PLANNING COMMITTEE

31st March 2016

THE FOLLOWING ALTERATIONS AND AMENDMENTS HAVE BEEN
RECEIVED SINCE THE PLANNING OFFICER'S REPORT WAS
PRESENTED TO MEMBERS

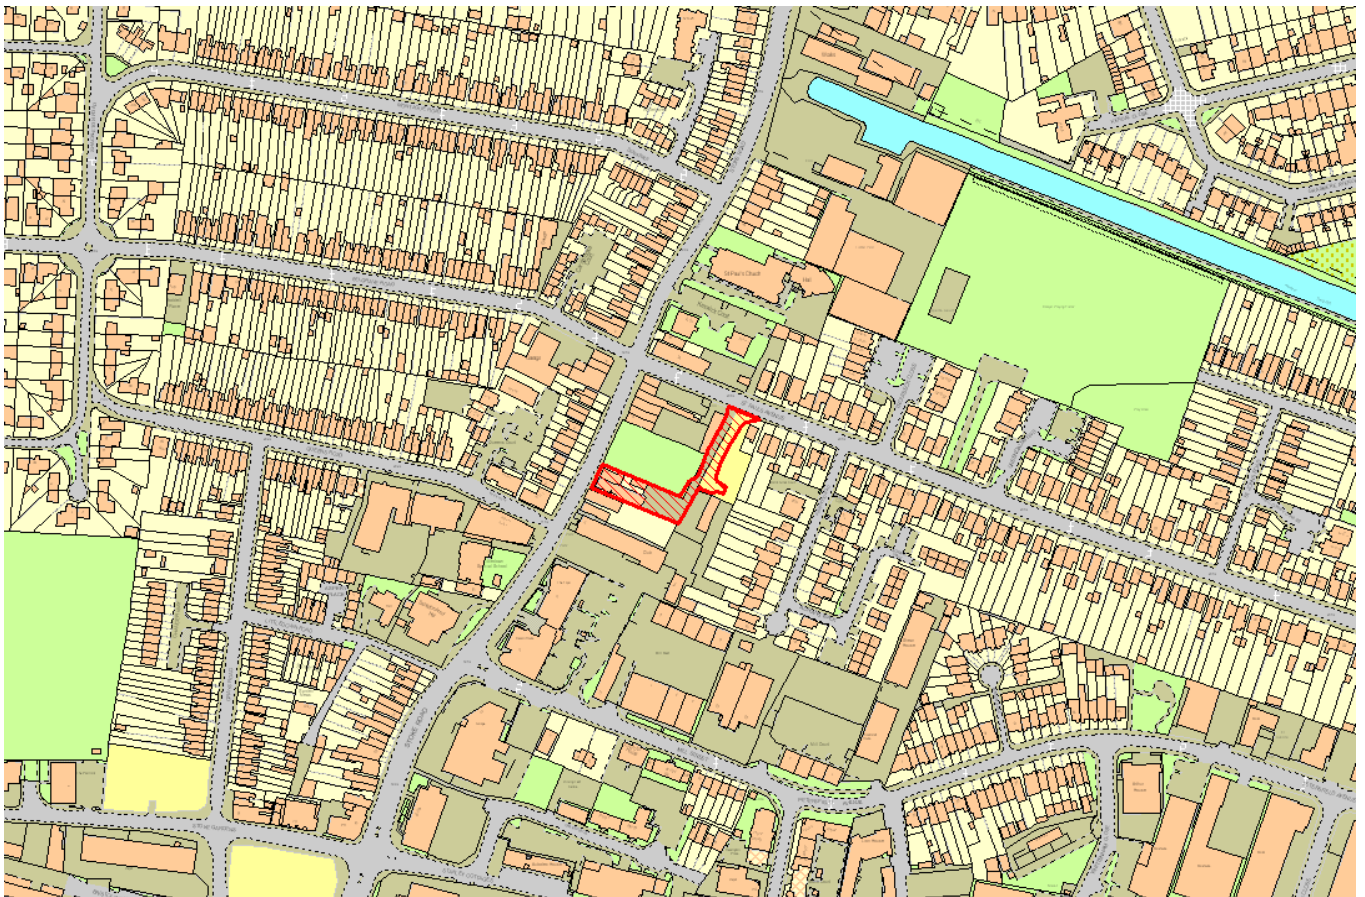
Revised drawing received is substantially satisfactory. It includes requested footway widening. A further change to be requested is moving end of garden parking for one plot to frontage of house and addition of visibility splays and frontage fence. The distance between existing and new dwellings has been clarified; all are over 20.5 except two at 19.9 m and 20.4 metres. A further change will be explored – slight widening of 5 homes to increase garden length or distance to homes opposite. Revised drawing 7705 Rev D Proposed Site Plan re condition 2
